STATE OF MAINE
DEPARTMENT OF TRANSPORTATION
16 STATE HOUSE STATION
AUGUSTA, MAINE 04333-0016

March 11, 2025
Subject: Roundabout Construction
State WIN: 026019.00
Location: **Damariscotta**
Amendment No. 2

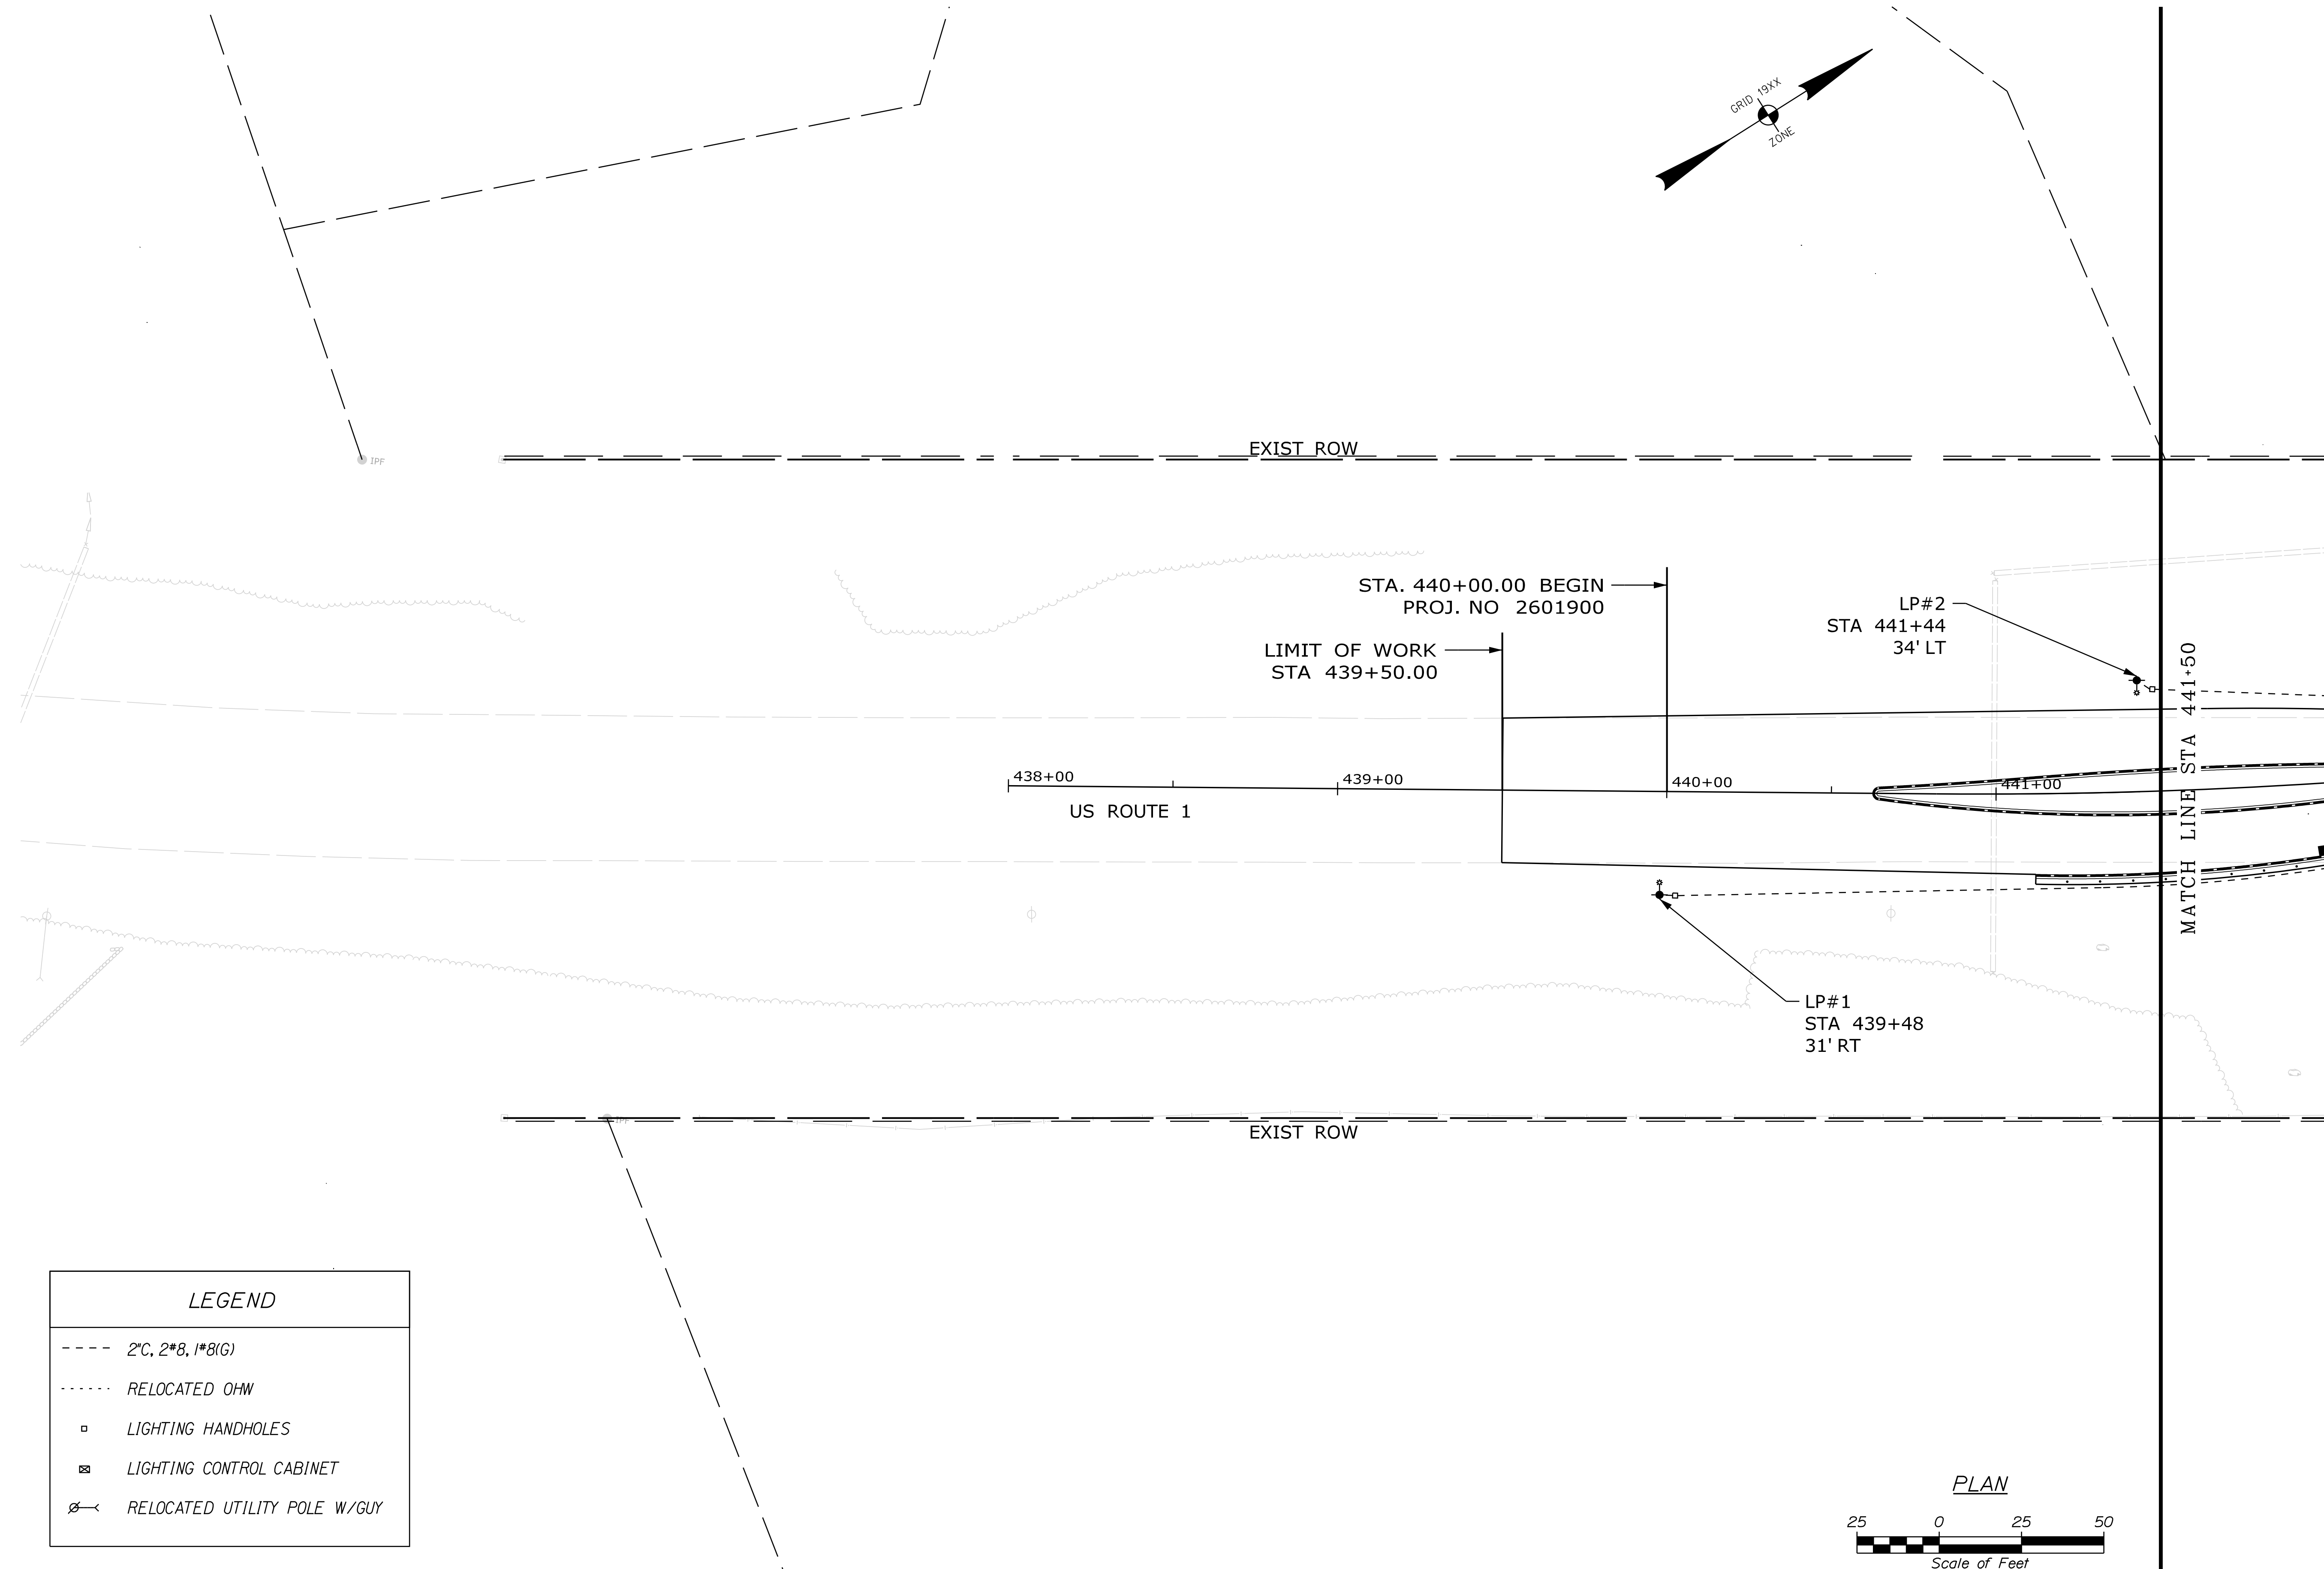
Question: The plans call for #12 THHN wire from the control cabinet to the light fixtures. Has voltage drop been taken into consideration?

Response: Plans mistakenly call for #12 THHN. Update wire to use #8 THWN wire from control cabinet to light base. Please see the revised Plan sheets dated 3/10/25.

LEGEND	
----	2°C, 2#8, 1#8(G)
-----	RELOCATED OHW
□	LIGHTING HANDHOLES
⊗	LIGHTING CONTROL CABINET
⊖←	RELOCATED UTILITY POLE W/GUY

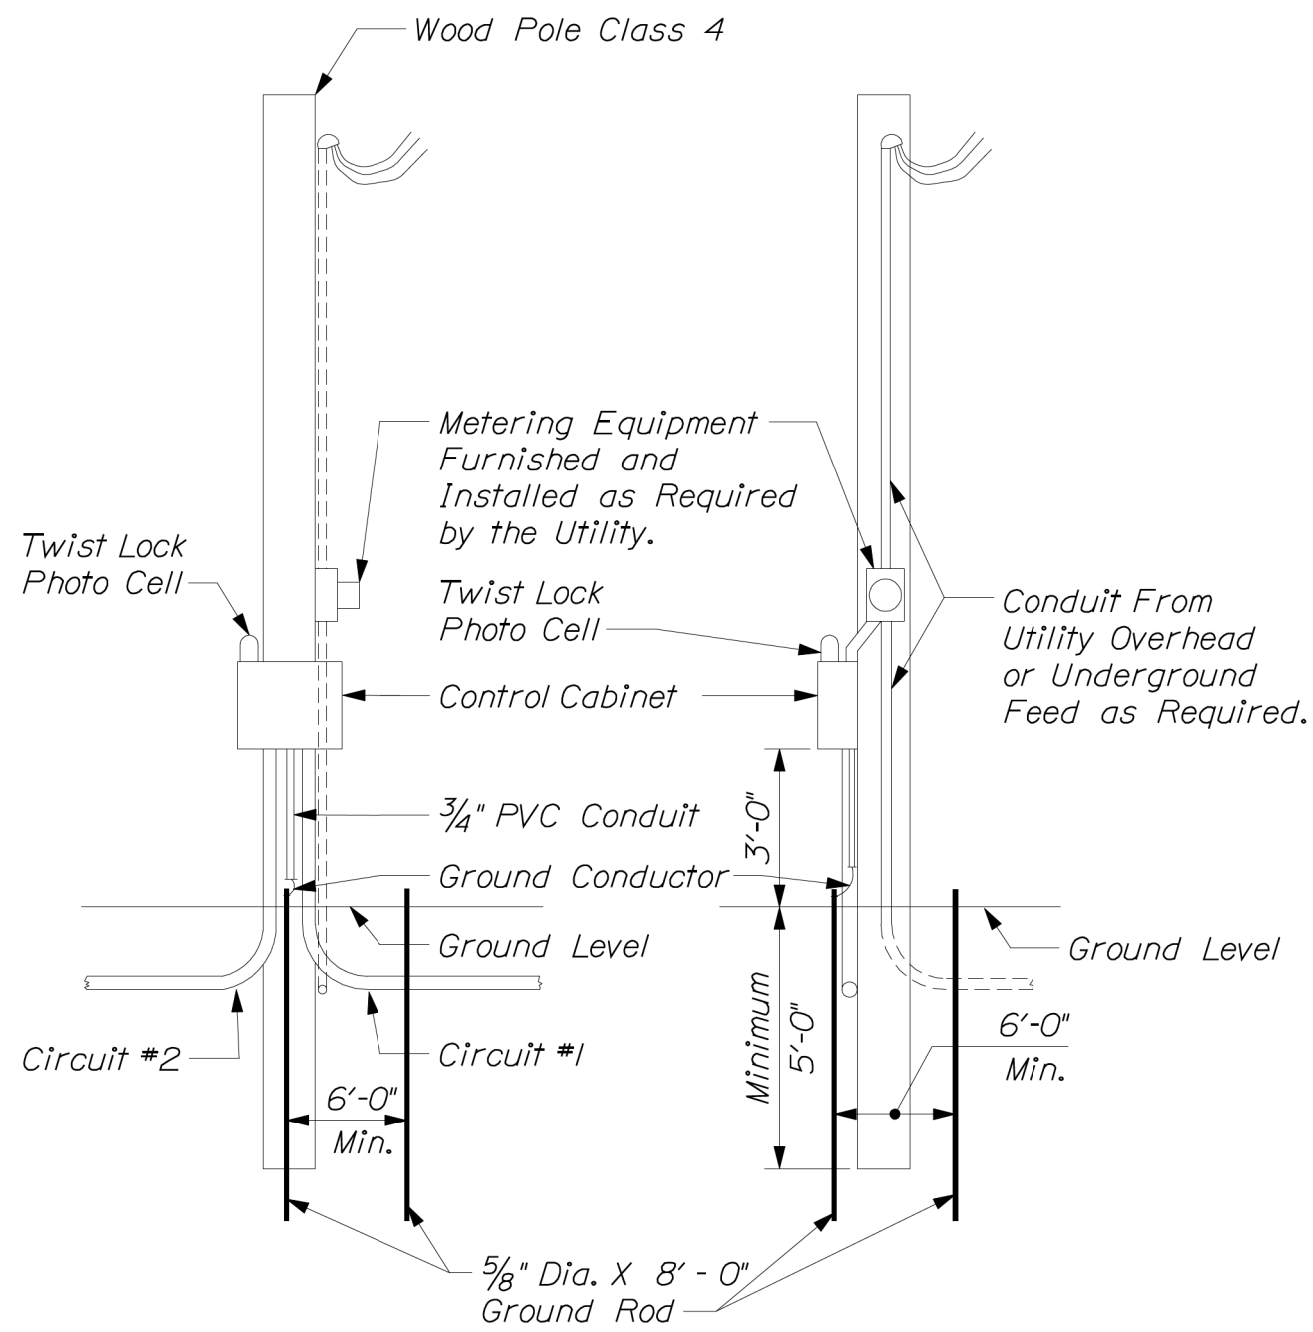
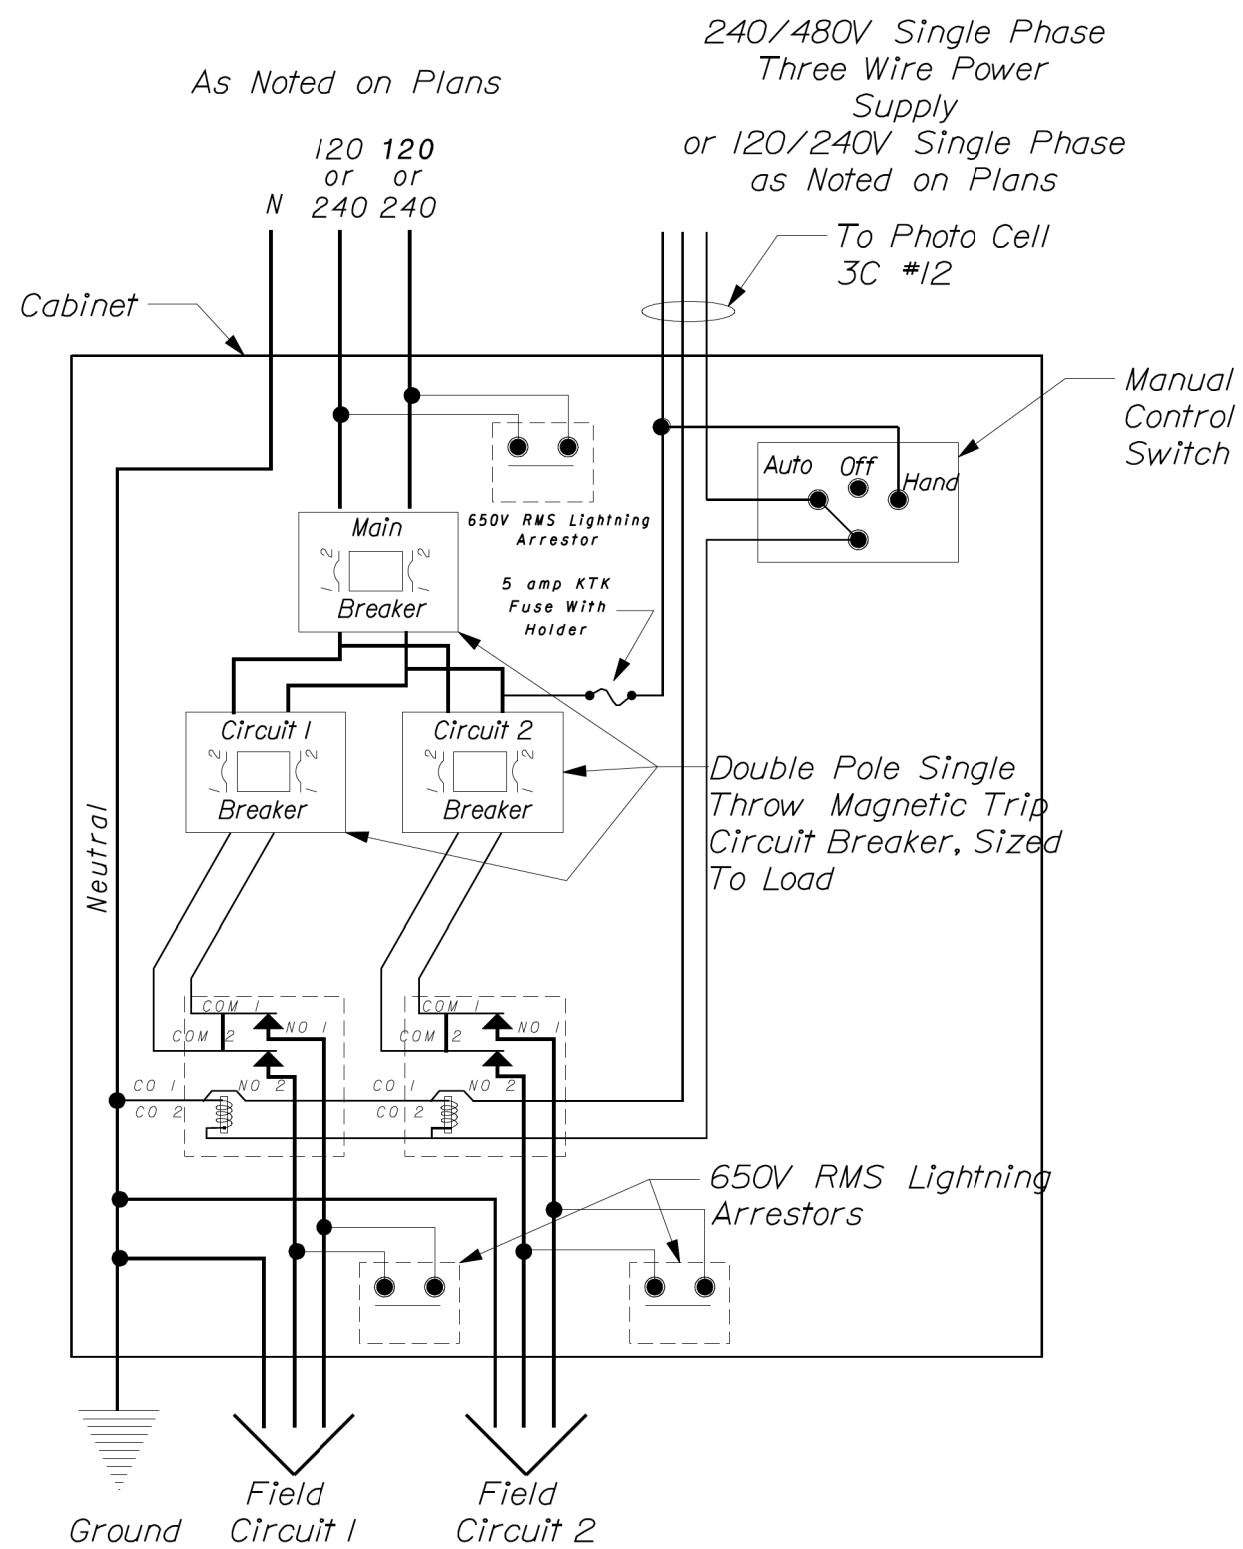
Question: Sheet 25 states that all conduit under roads will be PVC coated RMC. Which pay item will this fall under?

Response: 626.251 Non-Metallic Under Pavement Conduit Linear Foot (Schedule 80 or greater rating)

-We are fine with SCh 80 PVC (no RMC) under the road. There shall also be no underground splices or splices in junction boxes. All splices will take place in poles. Please see the revised SOI and Plan sheets dated 3/10/25.

13. ALL CONDUITS SHALL BE 2" MINIMUM SCHEDULE 40 PVC DIRECT-BURIED, UNLESS OTHERWISE NOTED. MINIMUM BURIAL DEPTH FOR CONDUIT SHALL BE 36".
14. CONDUITS UNDER ROADWAY SHALL BE SCHEDULE 80 PVC.

15. ALL WIRES FOR LIGHTING CIRCUITS SHALL BE A MINIMUM OF 8 AWG WIRE. ALL WIRE FROM THE CONTROL CABINET TO THE LIGHT POLE BASE SHALL BE A MINIMUM OF 8 AWG THWN WIRE.
